PROPOSED SEWAGE DISPOSAL SYSTEM PLAN

TAX MAP F LOT 3-2
WILTON, NEW HAMPSHIRE
(ISAAC FRYE HIGHWAY)

SAN-KEN HOMES, INC.
586 TURNPIKE ROAD - NEW IPSWICH, NH 03071

SCALE: 1" = 20' FEBRUARY 22, 2021

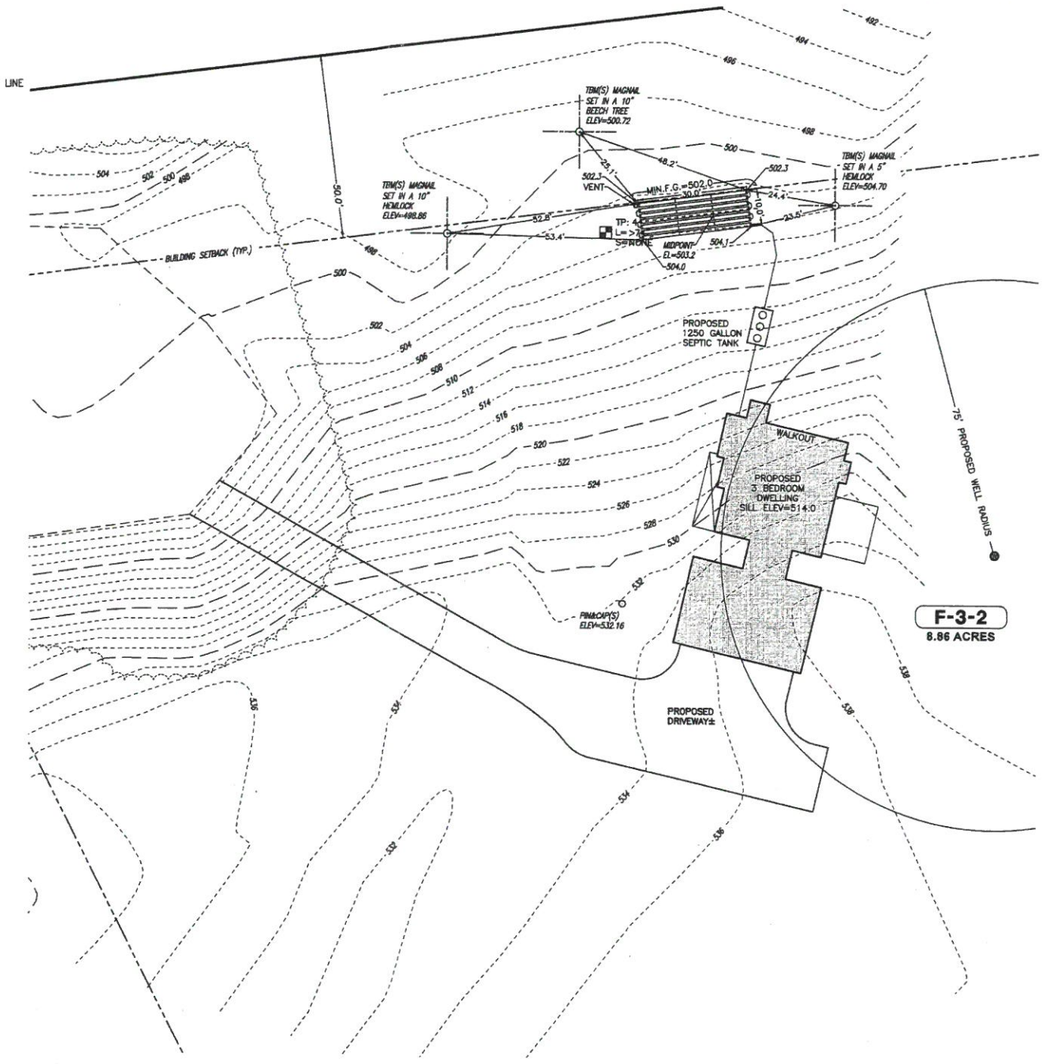
DUE TO SHWT AT >74" THE BOTTOM OF THE EFFLUENT DISPOSAL SYSTEM (EDS) SHALL BE CONSTRUCTED AT 500.0 ELEVATION. THIS IS APPROXIMATELY 4.1' ~~ABOVE~~ / BELOW ~~ORIGINAL~~ EXISTING GROUND ON THE HIGH CONTOUR OF THE EFFLUENT DISPOSAL SYSTEM (EDS).
LEACHFIELD IS TO BE REBUILT IN PLACE IF REPLACEMENT BECOMES NECESSARY.
SUBDIVISION APPROVAL # > 5 ACRES
PREVIOUS CONST. APPROVAL #
DEED REFERENCE: HILLSBOROUGH COUNTY BOOK/PAGE #9186/2436
